New Albany Planning Commission Meeting Agenda

Planning Commission Staff Report November 17, 2025 Meeting

DUTCH BROS COFFEE SHOP FINAL DEVELOPMENT PLAN

RE: Dutch Bros Coffee – Final Development Plan, Conditional Use and Variance FDP-83-2025, CU-84-2025 and VAR-85-2025 9930 Johnstown Road

SITE PLAN

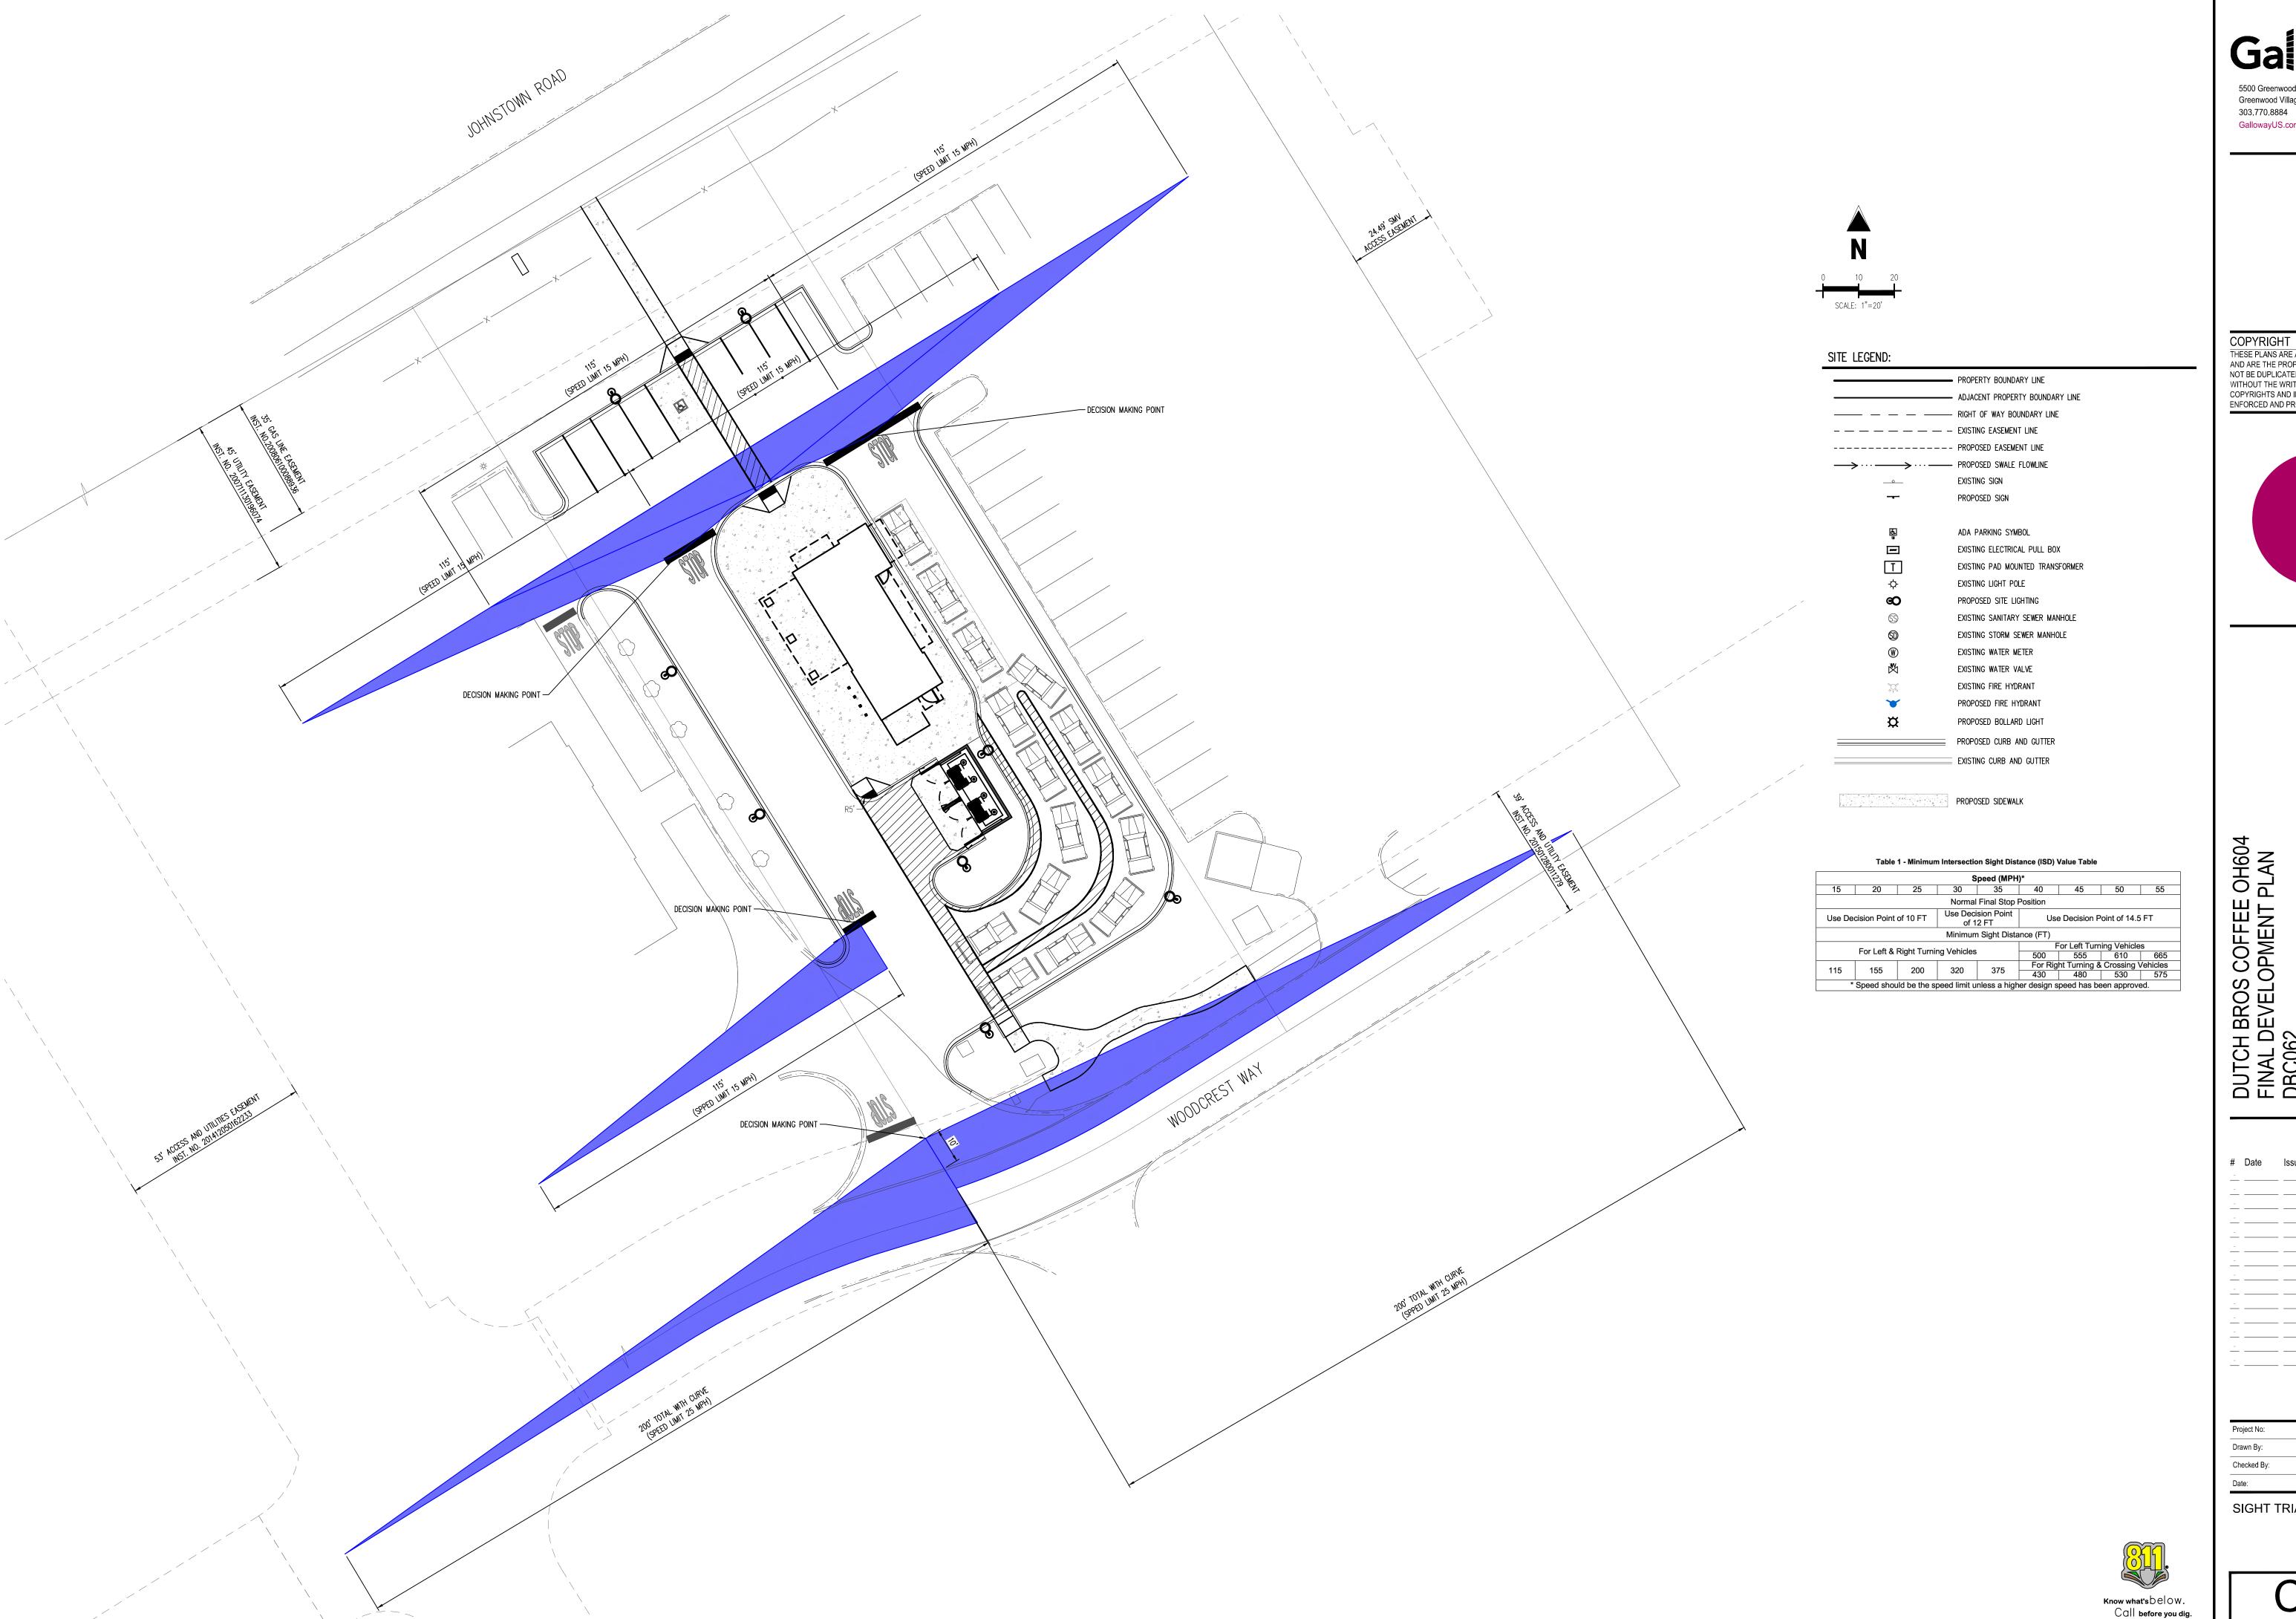
- 3. Please remove the "Preliminary...Not for Construction" note from all sheets.
- 4. Revise the month reference on the Cover Sheet title block.
- 5. Refer to sheet C1.0. Show the instrument number for the recorded cross access easement.

- 6. Provide a Fire Truck Turning Radius analysis.
- 7. Update the Site Data Table on sheet C1.0 to show stalls/ADA stalls required.
- 8. Add a major flood routing arrow to the legend on sheet C2.0 and show major flood routing in plan view.

Response: Instrument number added for the cross-access easement.

- 6. Provide a Fire Truck Turning Radius analysis. Response: Fire Truck Analysis has been provided.
- 7. Update the Site Data Table on sheet C1.0 to show stalls/ADA stalls required. Response: Site data table has been updated.
- 8. Add a major flood routing arrow to the legend on sheet C2.0 and show major flood routing in plan view.

ROOF PLAN

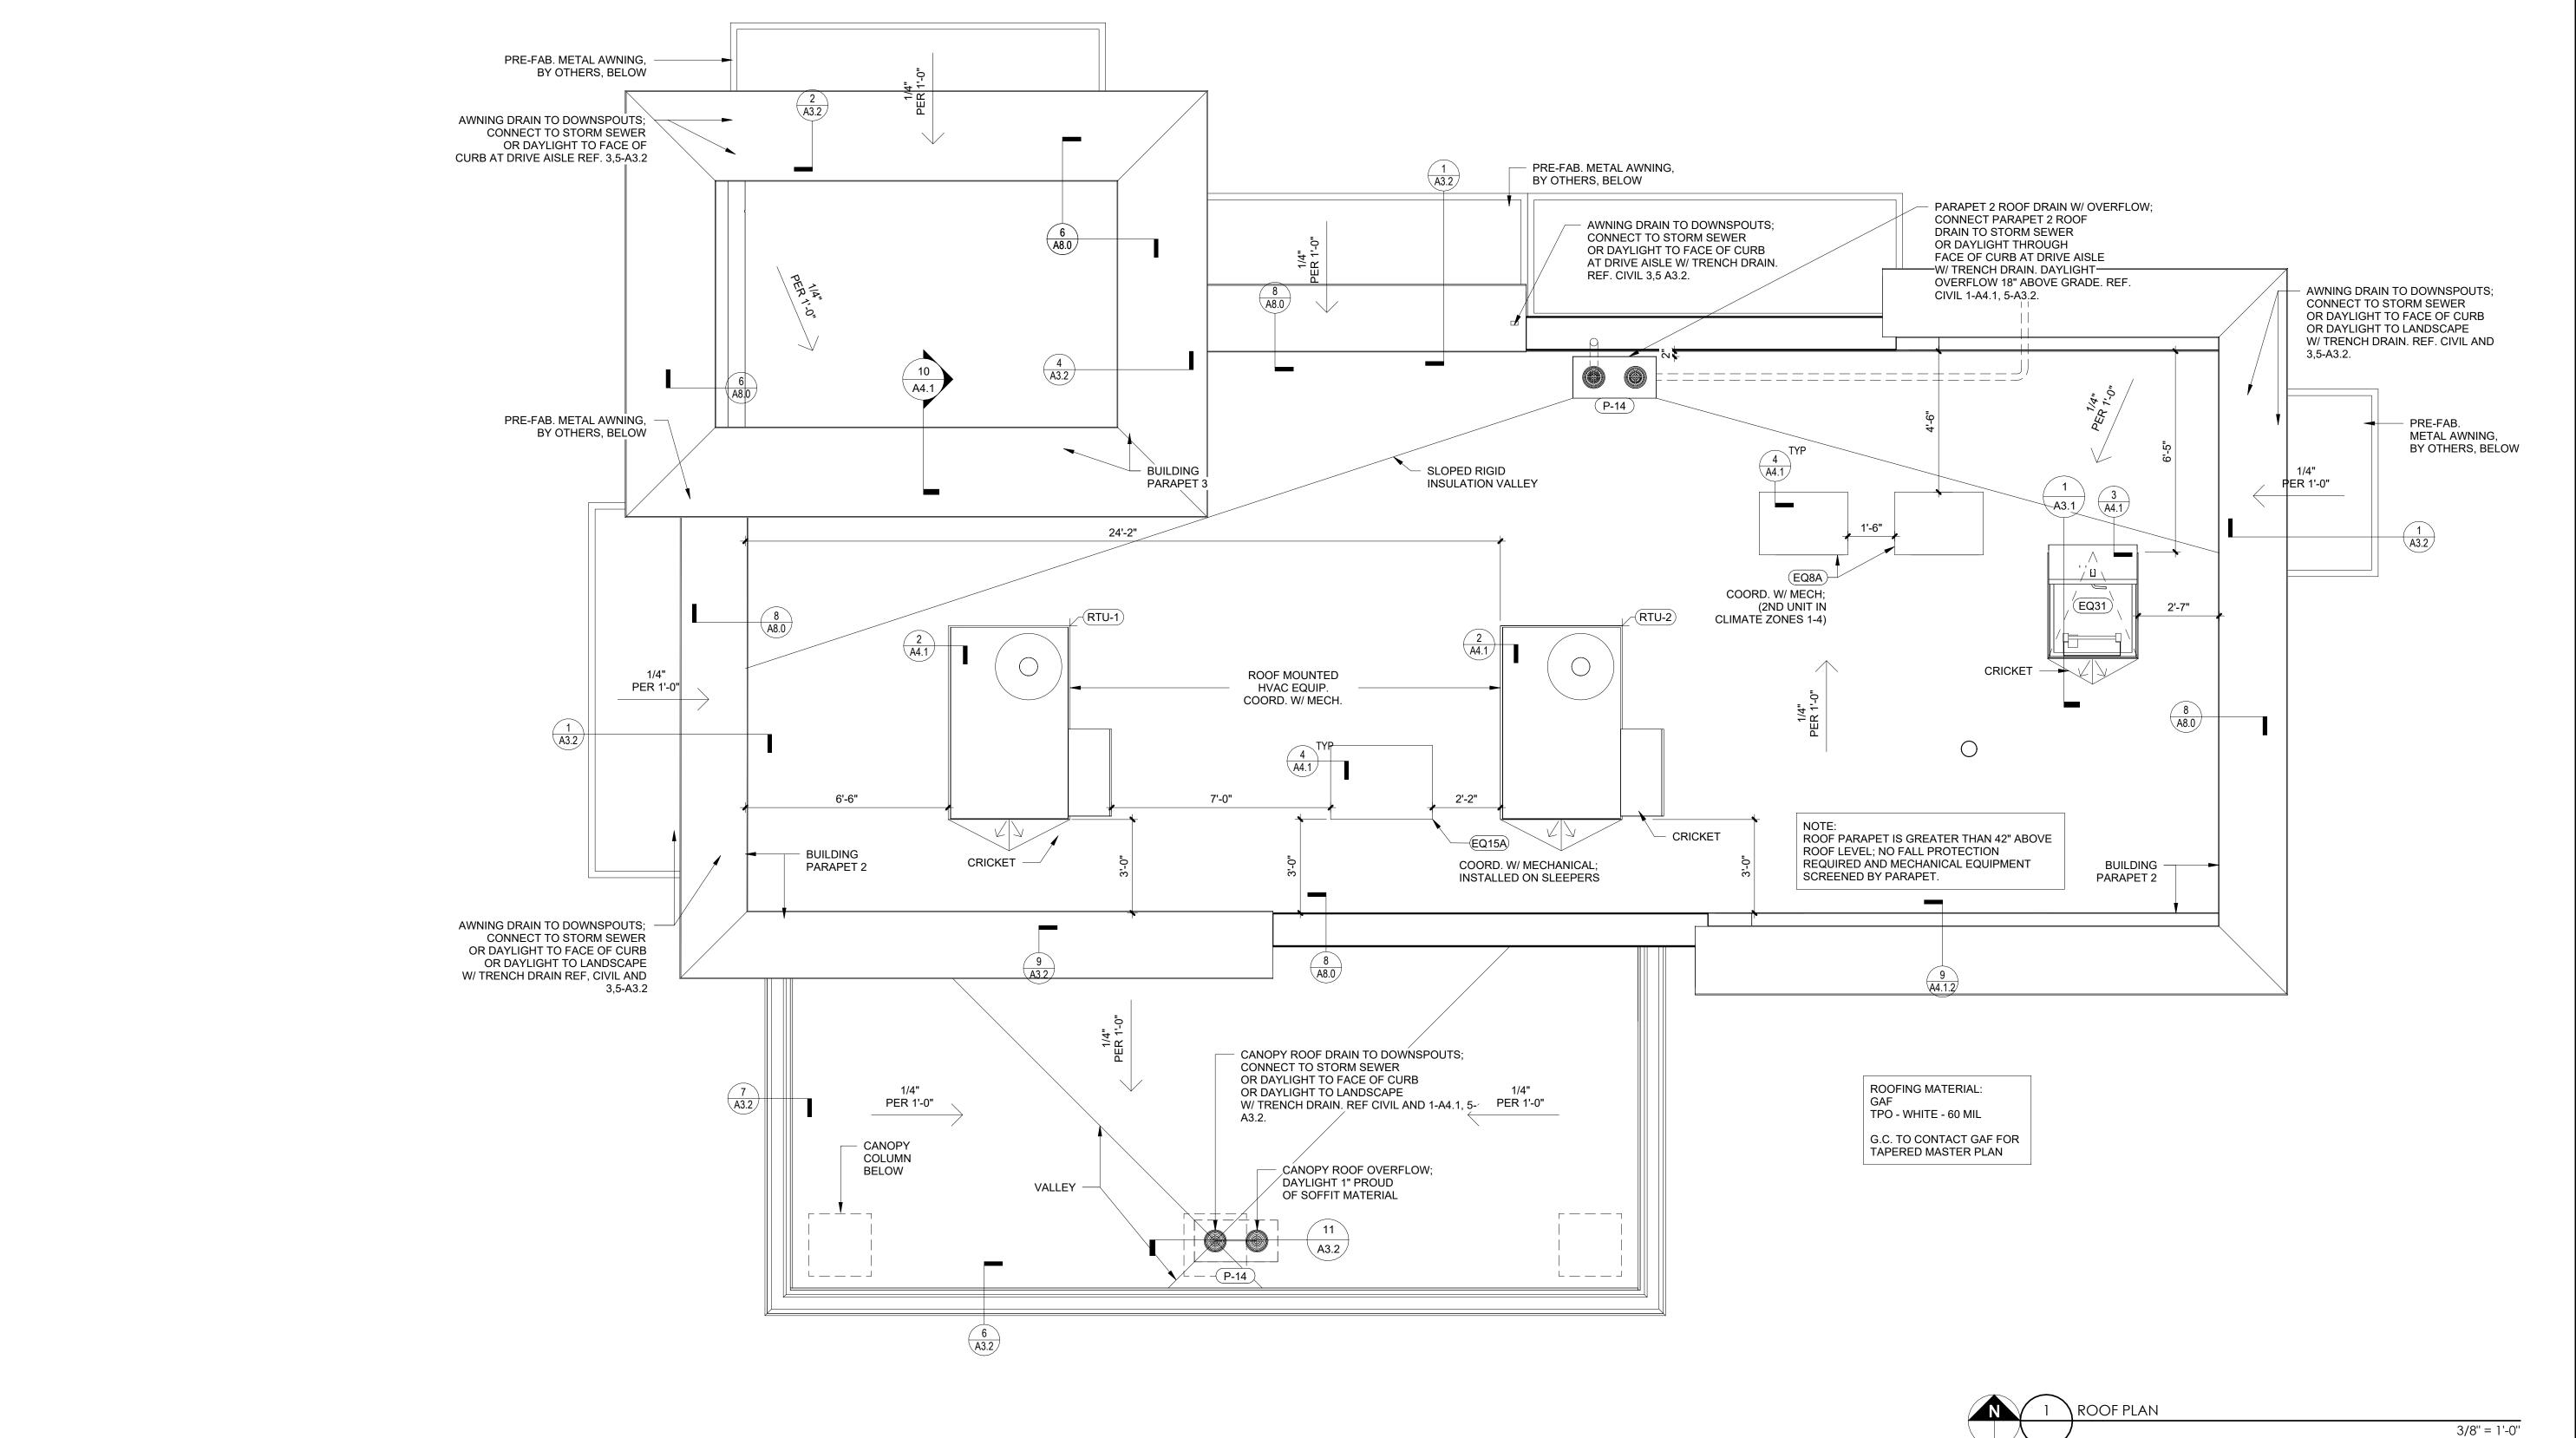
- 7. A roof plan was submitted. In accordance with zoning text section 8a.05(2), <u>staff</u> recommends a condition of approval that all rooftop mechanical equipment not be visible from and screened from all public roads and adjacent properties (condition #2).

Response: Set back dimension added, pavement set 20' back form access easement to
 meet standard.
- Provide a roof plan that shows how rooftop equipment will be fully screened.

Response: Roof plan has been provided, please see updated FDP set.

BUILDING ELEVATIONS - COLOR

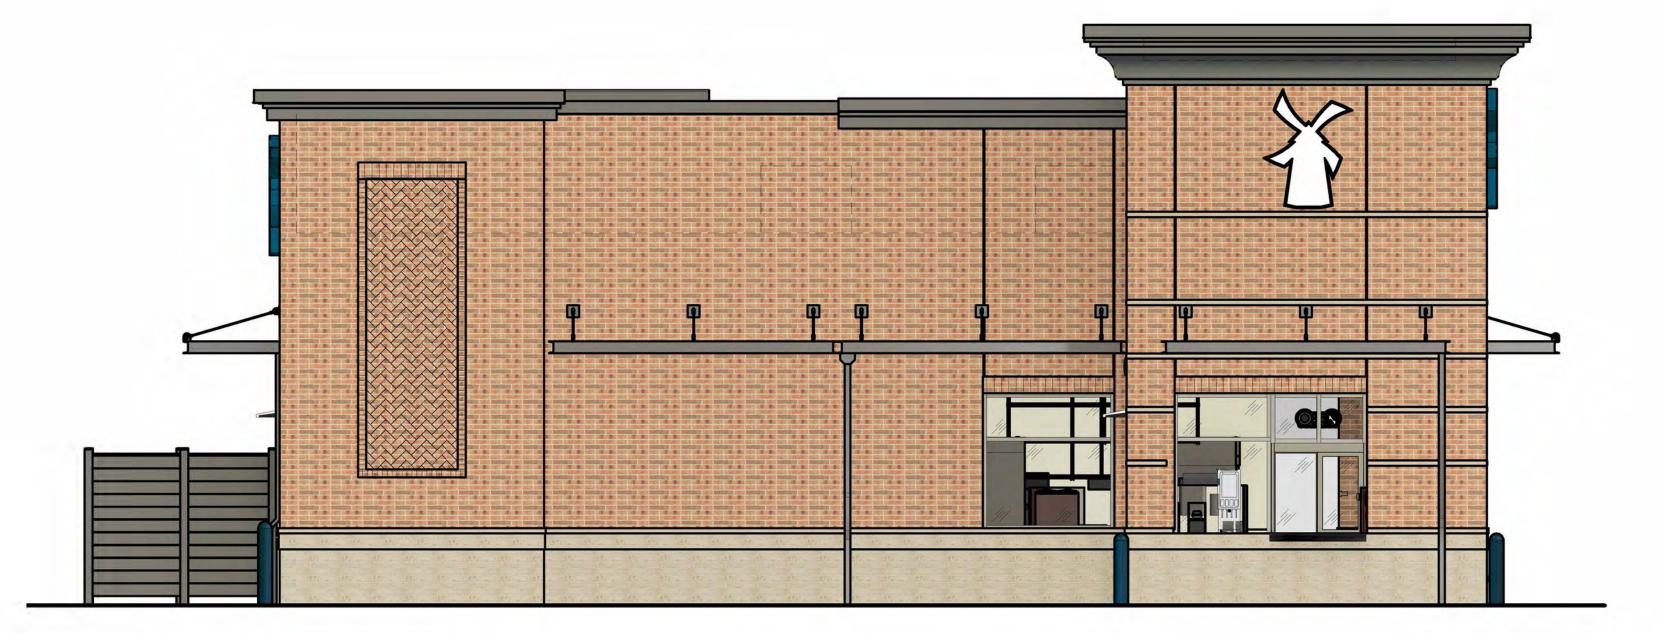
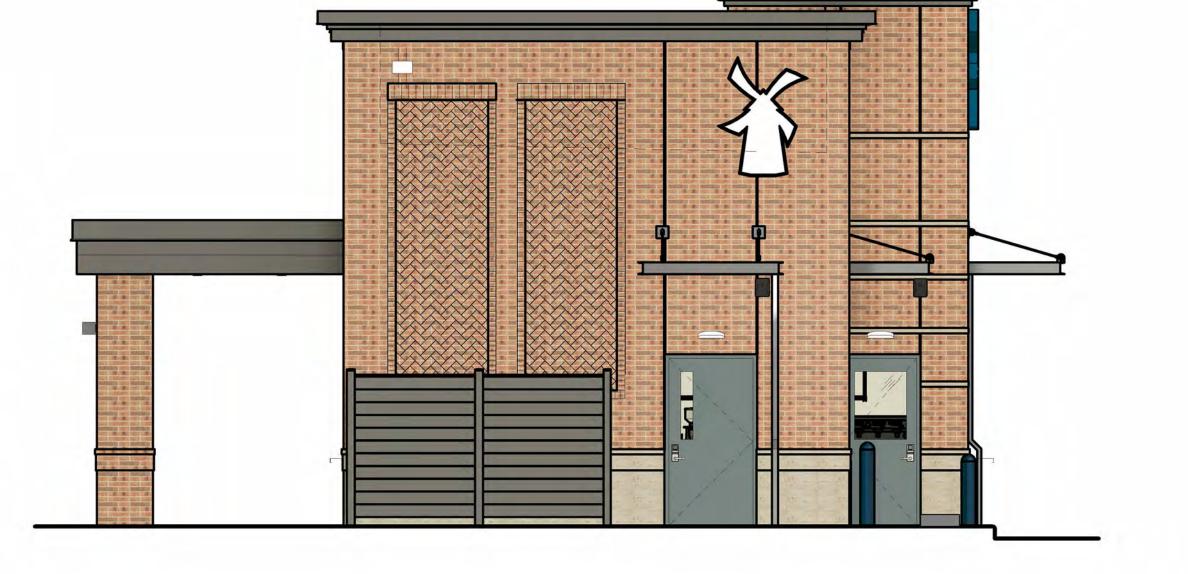
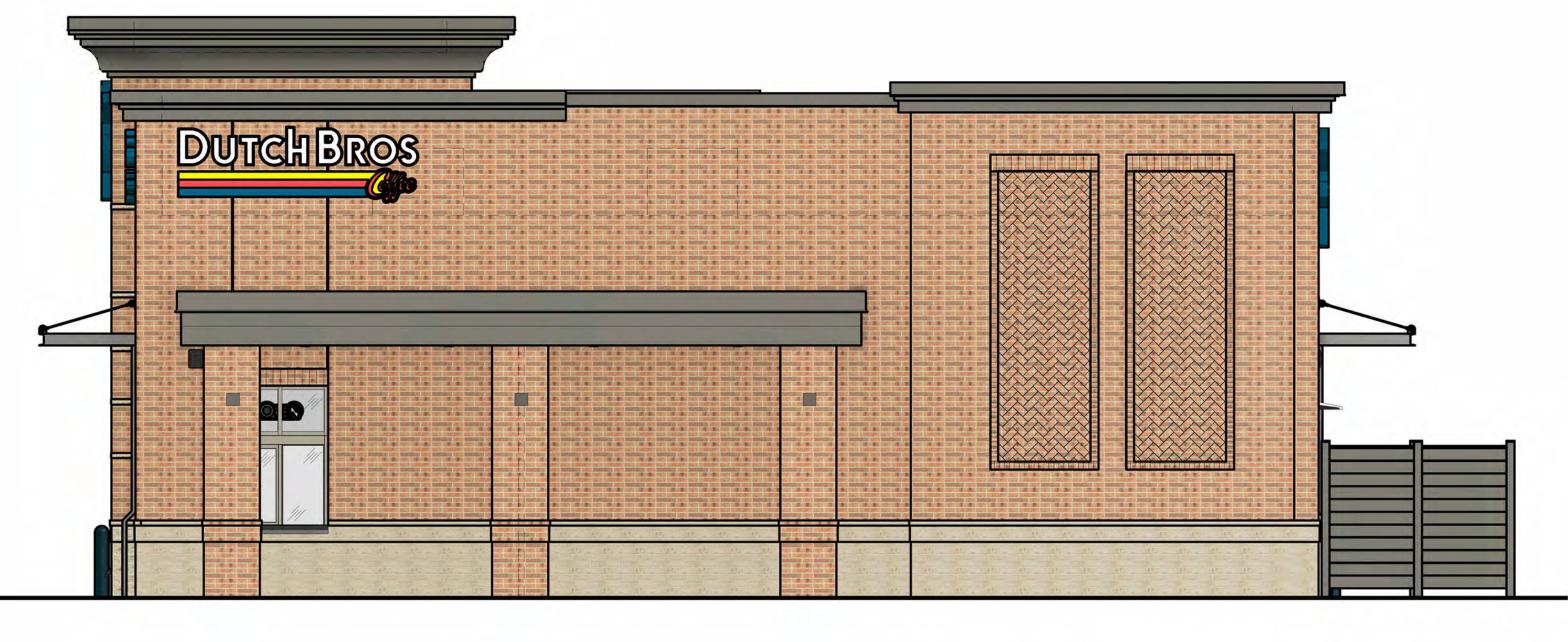
- 9. The City Architect reviewed the proposed final development plan and found the design to be well-proportioned and well-detailed, with the projected overhangs substantially helping to provide detail on the windowless façade, especially on the western side elevation on which a deep covered patio is proposed. The City Architect recommended the applicant include faux or bricked-in windows on the building façade where there is no projected overhang, and the applicant has fulfilled this request.

- Response: Signage package provided by sign consultant, included with submittal along with a Variance request.
- Staff recommends adding "fake"/bricked windows to the side facades. Many of our design standards recommend or require buildings to have windows on all sides to appear more "lived in" and to help break up the façade, though this is not necessarily required.

Response: Building elevations have been updated, please reference new building elevations in the FDP set.
- Provide the setback of the pavement from Woodcrest Way in the site plans. The PUD requires
 this to be 20 feet, but staff is supportive if this requires a variance.
